**PROPOSED AGENDA
REGULAR MEETING OF
THE CHARLOTTE PLANNING COMMISSION**

To: City of Charlotte – Planning Commission
From: Assistant Fire Chief Tyger Fullerton
Date: May 20, 2025
Subject: Site Plan Review – 400 Parkland Dr. (Combs Industrial Park)

COVER SHEET

Addition & Renovation
Markdom Renovation
400 Parkland Dr.
Charlotte, MI 48813

SITE LAYOUT, GRADING, AND SESC PLAN
400 PARKLAND DR
PART OF SECTION 6, T2N, R4W
CITY OF CHARLOTTE, EATON COUNTY, MI

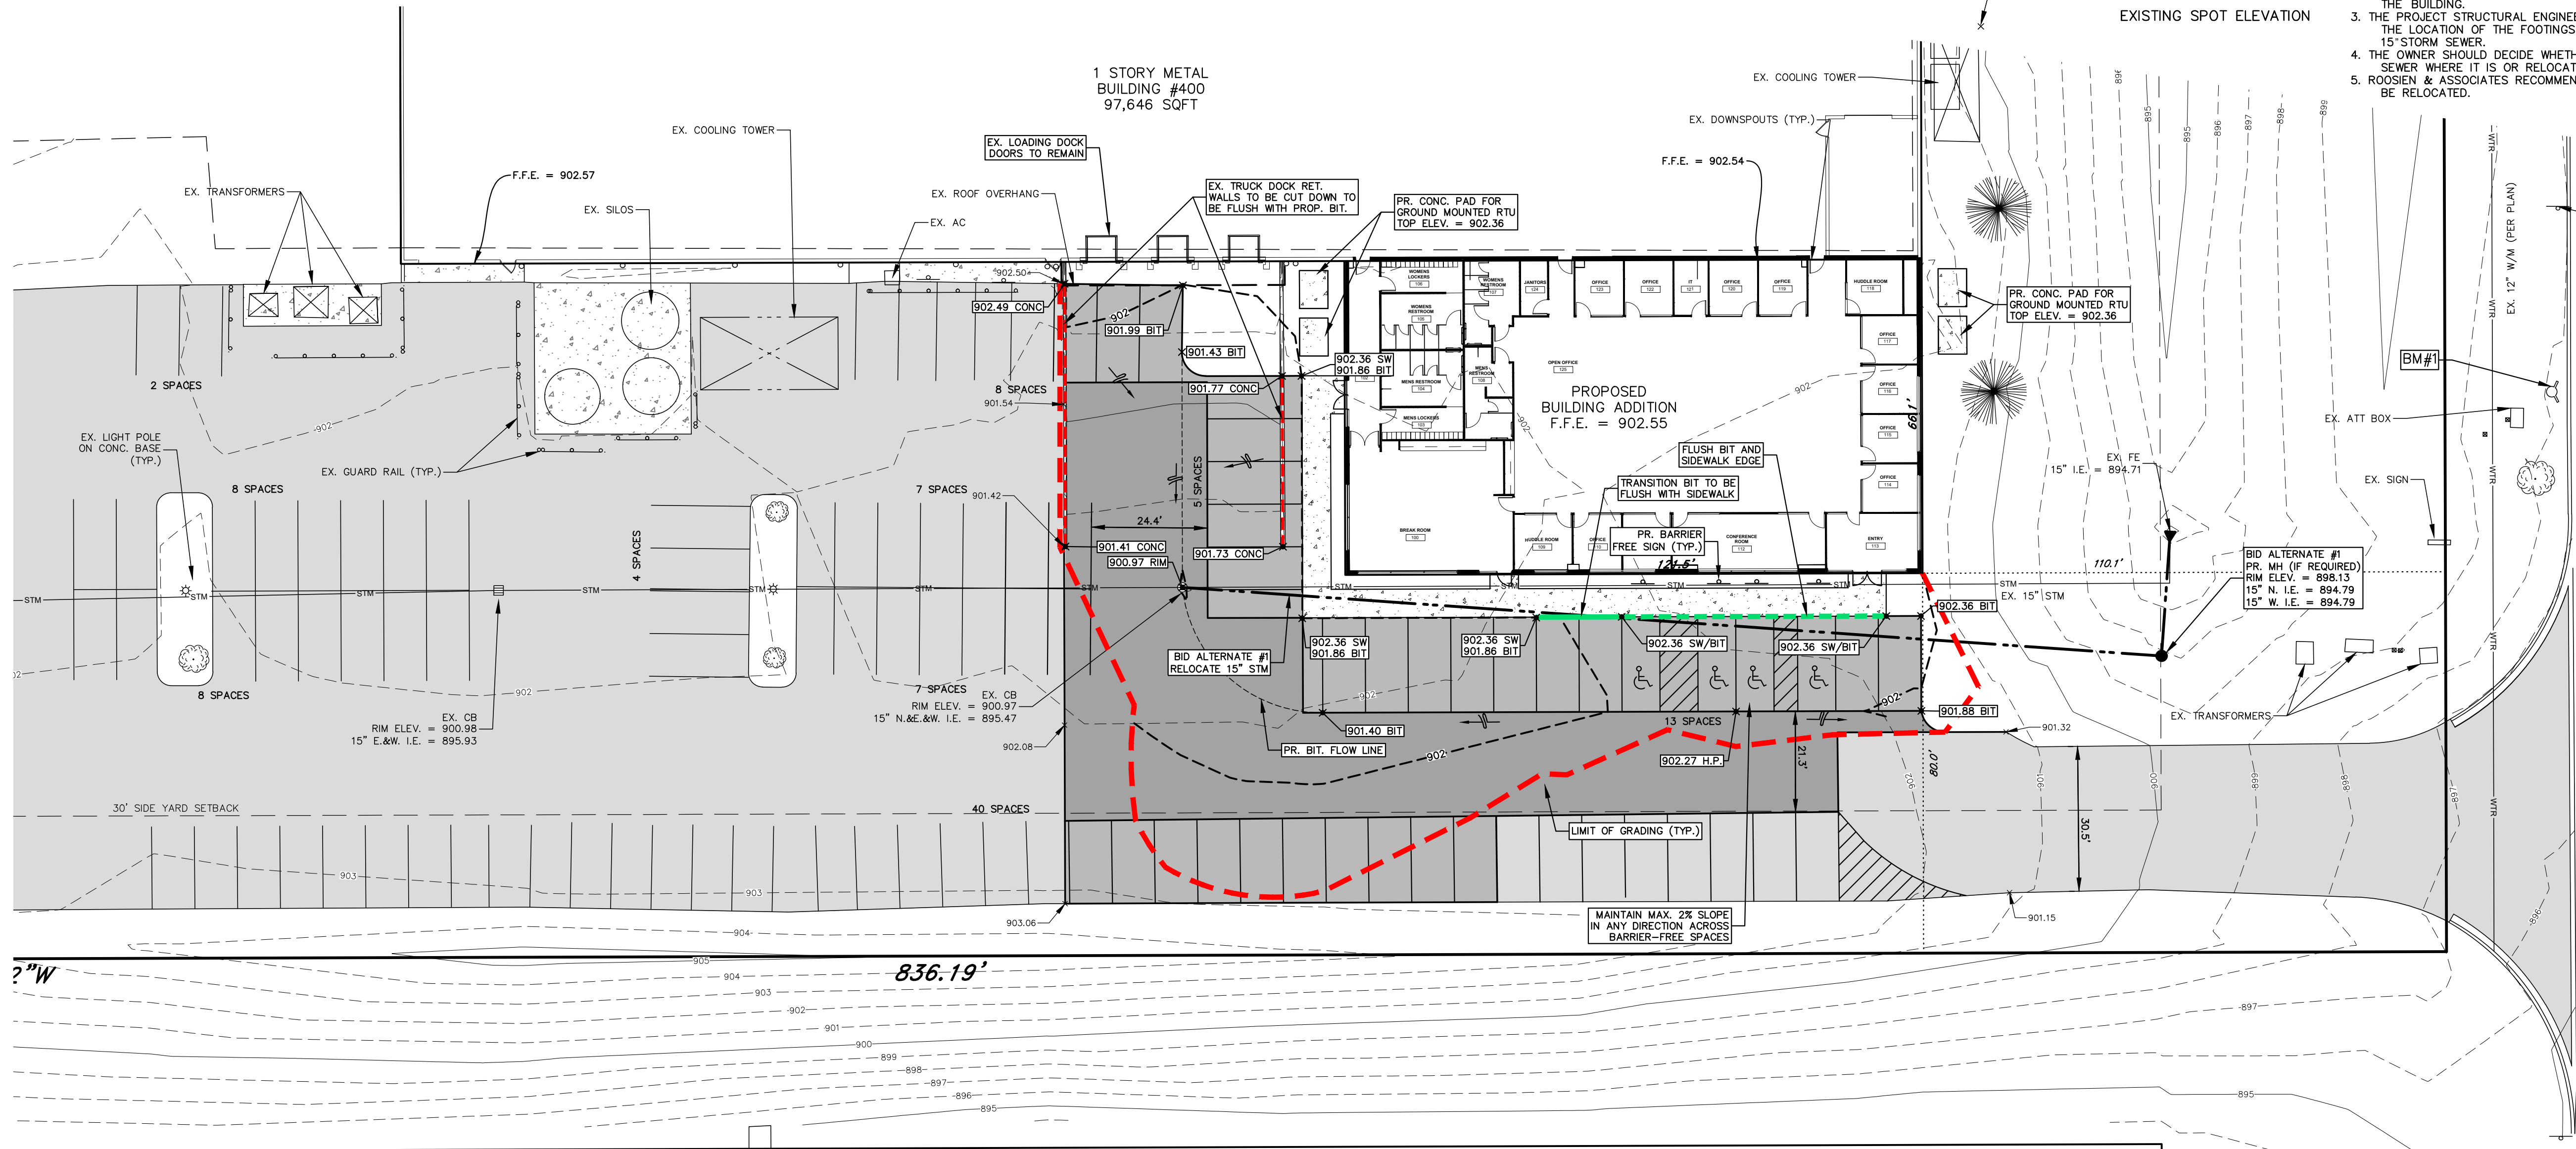
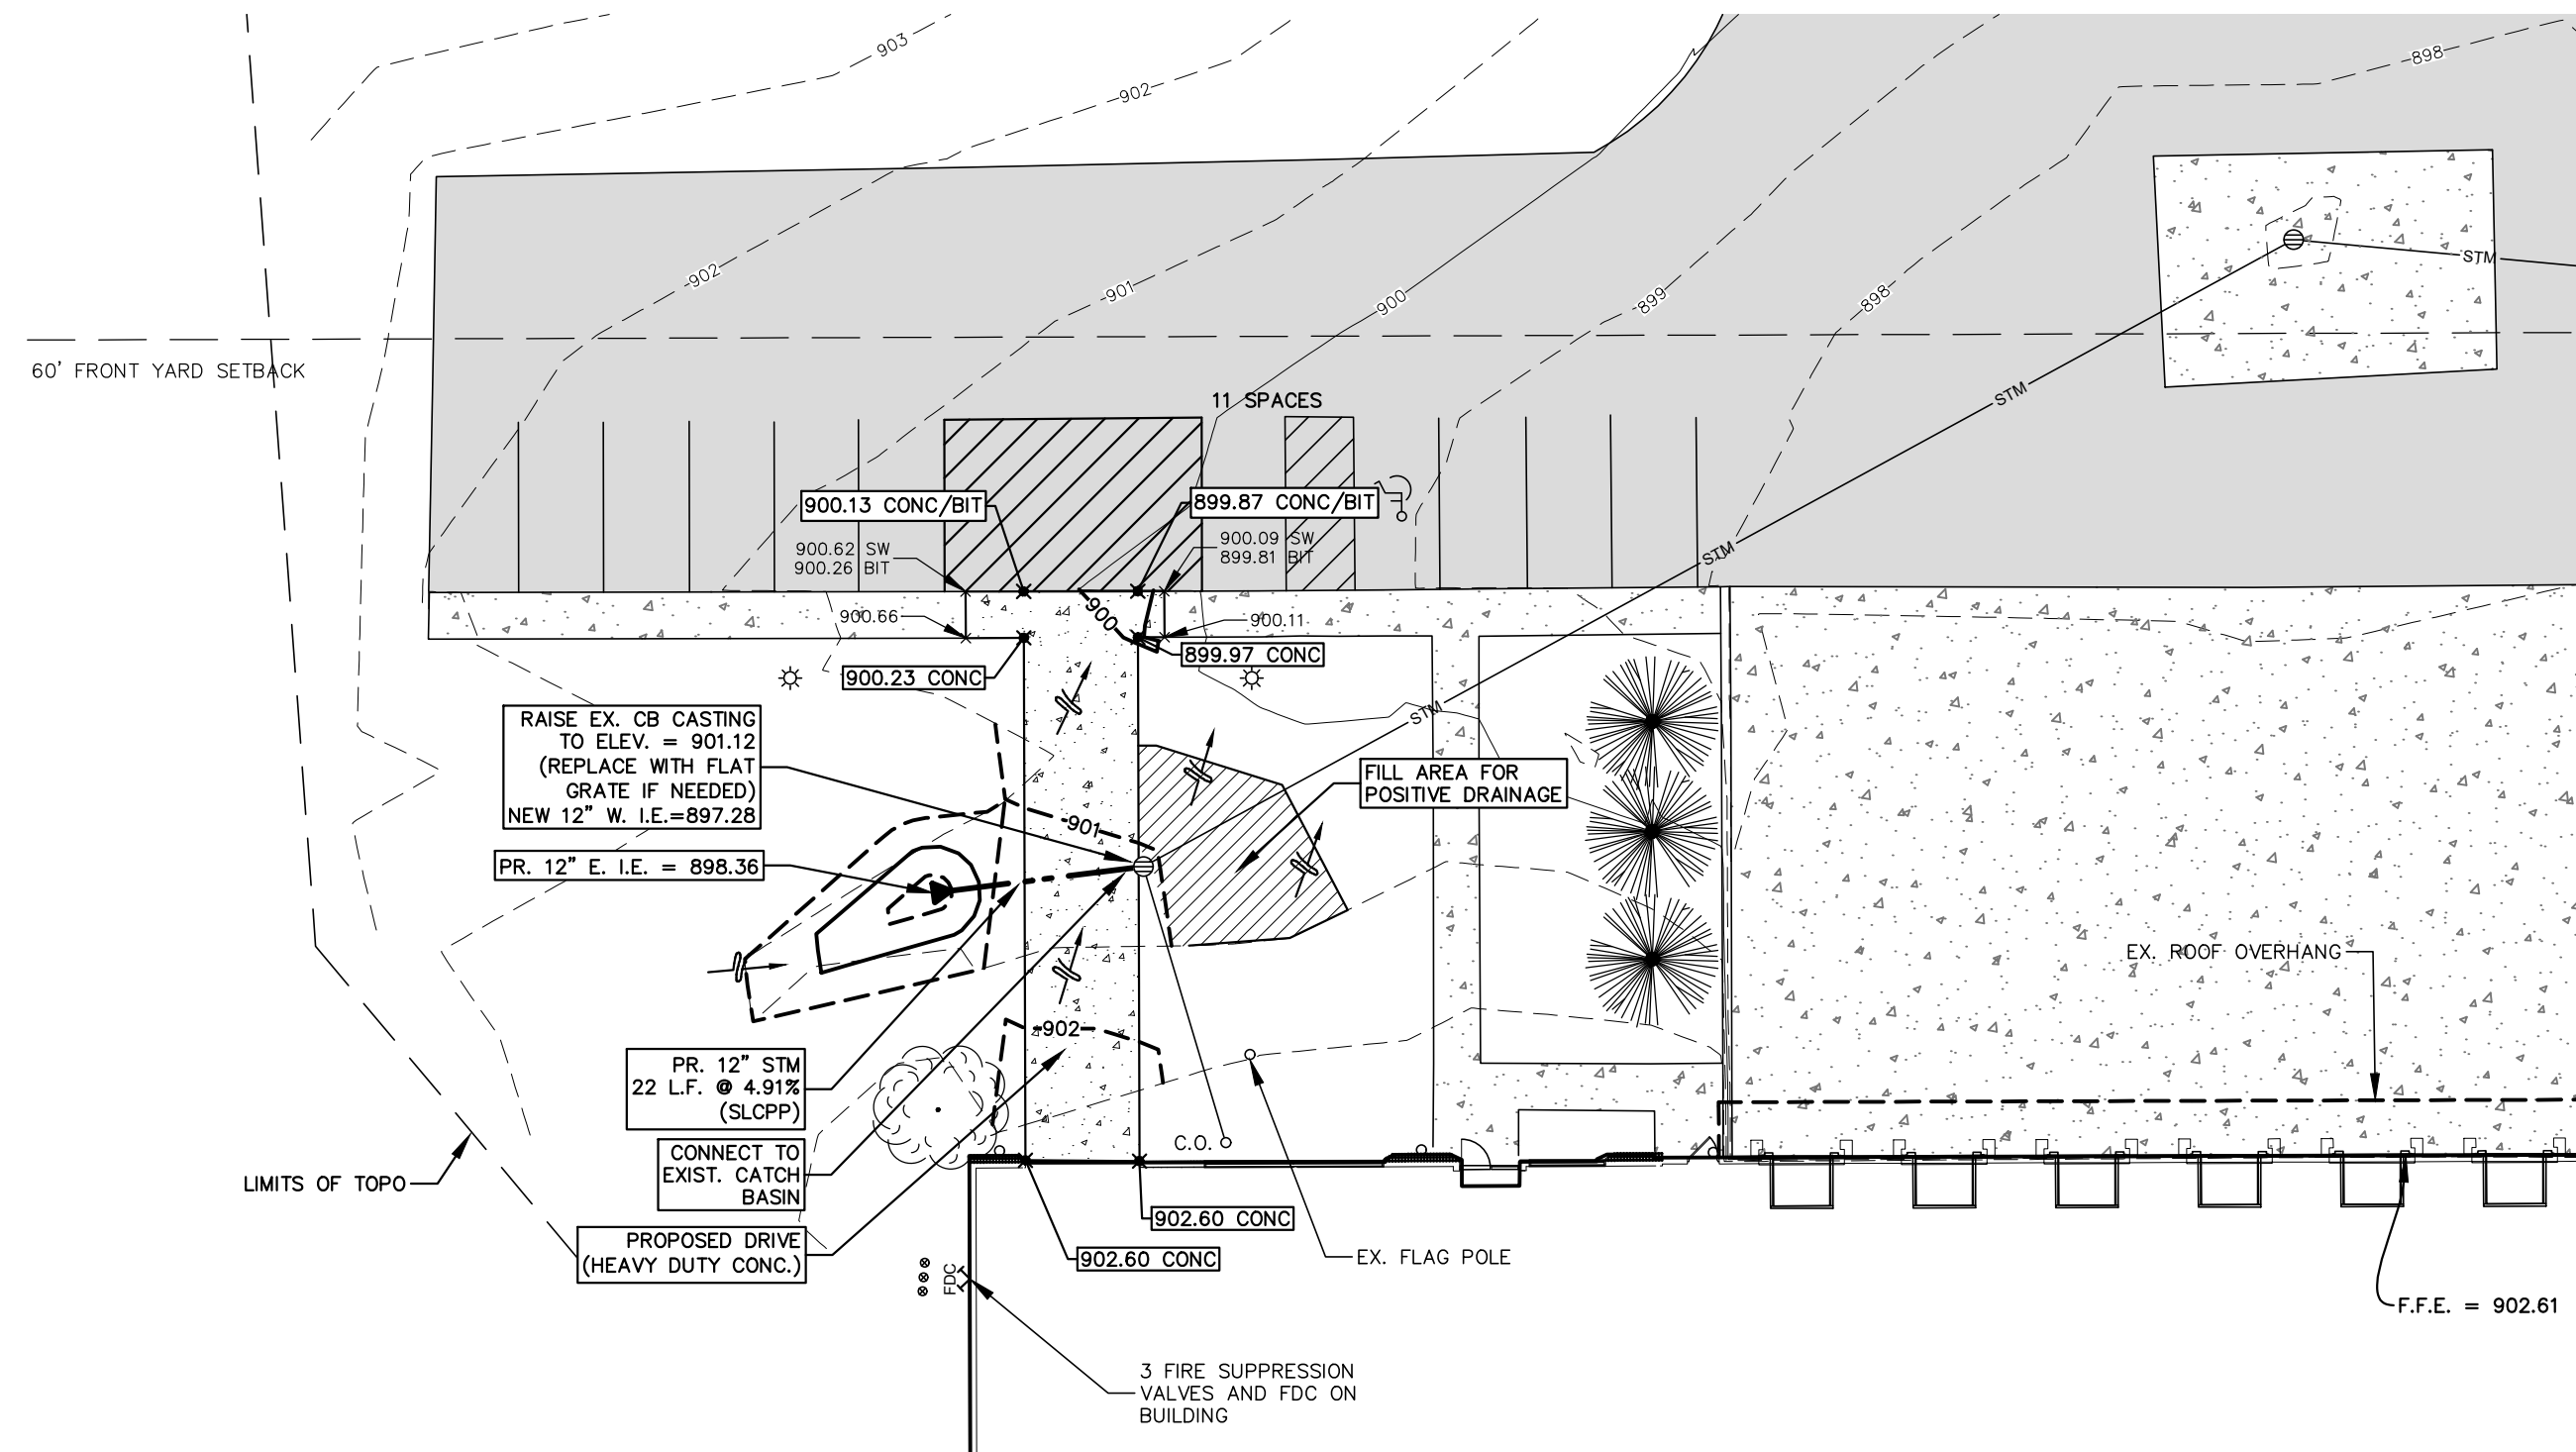
The City of Charlotte has received a zoning approval request submitted by Anderson Construction LLC on behalf of Markdom International Inc, for a proposed project located at 400 Parkland Drive, within the Combs Industrial Park. As you may be aware, this property was acquired in 2024 by an associated property company of Markdom, a Canadian-based plastic molding manufacturer now initiating production operations here in Charlotte. The applicant has submitted plans for an approximately 8,000 square foot building addition, and an estimated total investment of 19 million into the property. The intended primary use of this new space is for office facilities, as well as bathroom and break areas, to support the operations within the existing 98,000 square foot manufacturing building.

Upon review of the submitted site drawings, we find that the proposed development complies with all zoning requirements, including setback and height restrictions. Furthermore, the site provides parking capacity that well exceeds the minimum requirement for projected shift staffing levels. The plan also reflects an increase in barrier-free parking spaces, ensuring full compliance with ADA and local accessibility standards.

Should the Planning Commission approve the site plan, it is important to note that subsequent approvals will still be required. A stormwater management plan must be reviewed and approved by the Eaton County Drain Commission & Department of Public Works. Additionally, any modifications or additions to water and sewer infrastructure must be permitted through the City of Charlotte Department of Public Works prior to the commencement of construction.

Based on our review and coordination with applicable departments, we recommend approval of the proposed site plan.
